## Groundwater Transfer Review Summary Form

Transfer/PA # T- 12969

## Ground Water Review Form:

Application: T-12969      Applicant Name: Blue Line Farms Inc. c/o Bob and Karl Dettwyler

### T-12969 Blue Line Farms, Inc.

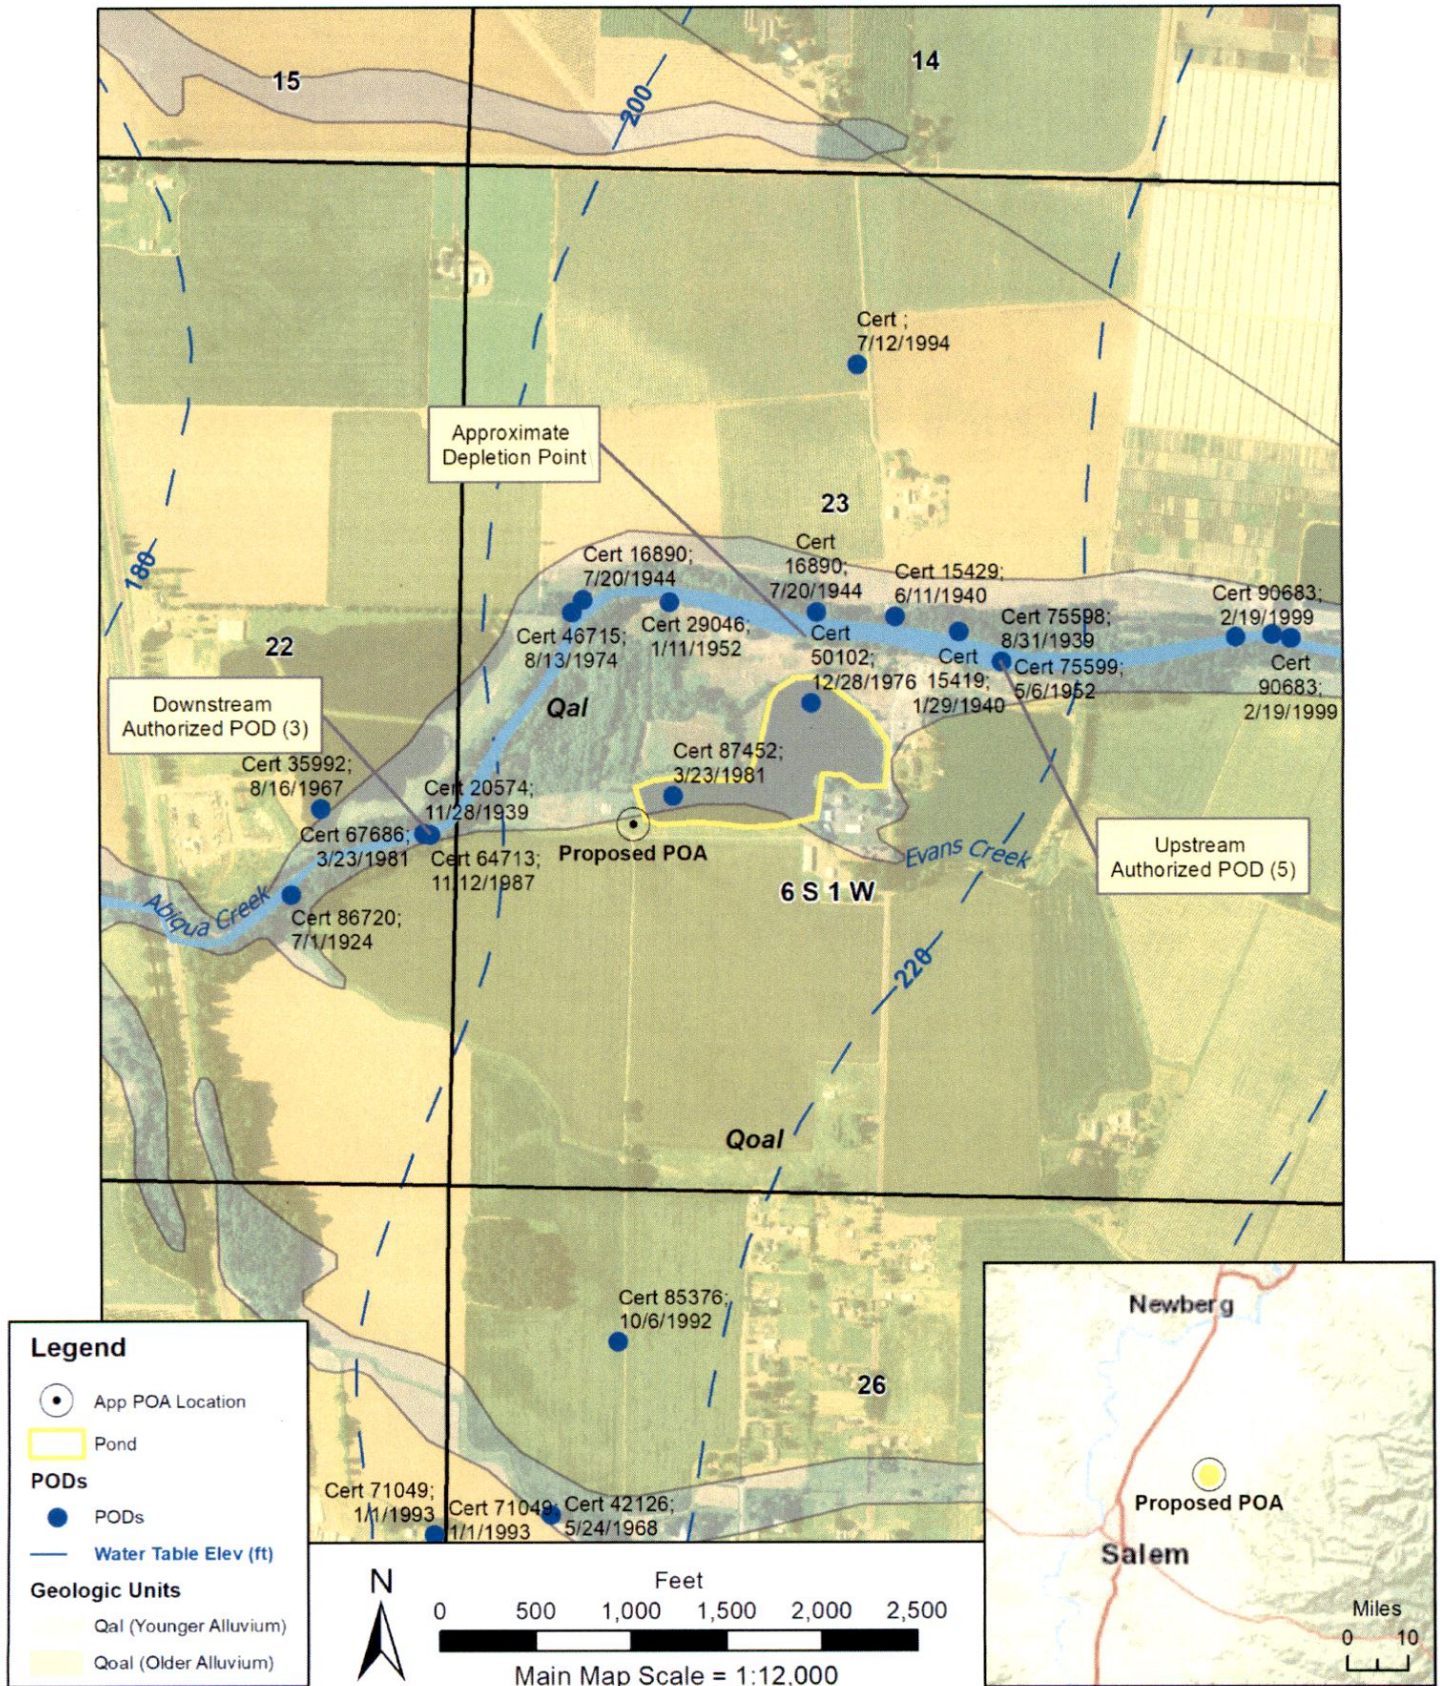
1. Basic description of the changes proposed in this transfer: Applicant proposes to transfer 8 certificated surface water irrigation rights with points of diversion (POD) on Abiqua Creek to a groundwater point of appropriation (POA) on the south side of an unlined ~11.6 acre pond, the nearest edge of which is ~200 ft from Abiqua Creek. The pond is a remnant of a former gravel quarry which mined the alluvial material adjacent to Abiqua Creek.

proposed POA (on the southwestern edge of the pond) will propagate almost instantaneously across the open water of the pond, **it is very likely that the proposed POA would meet the definition of similarity specified in OAR 690-380-2130(11)(b).**
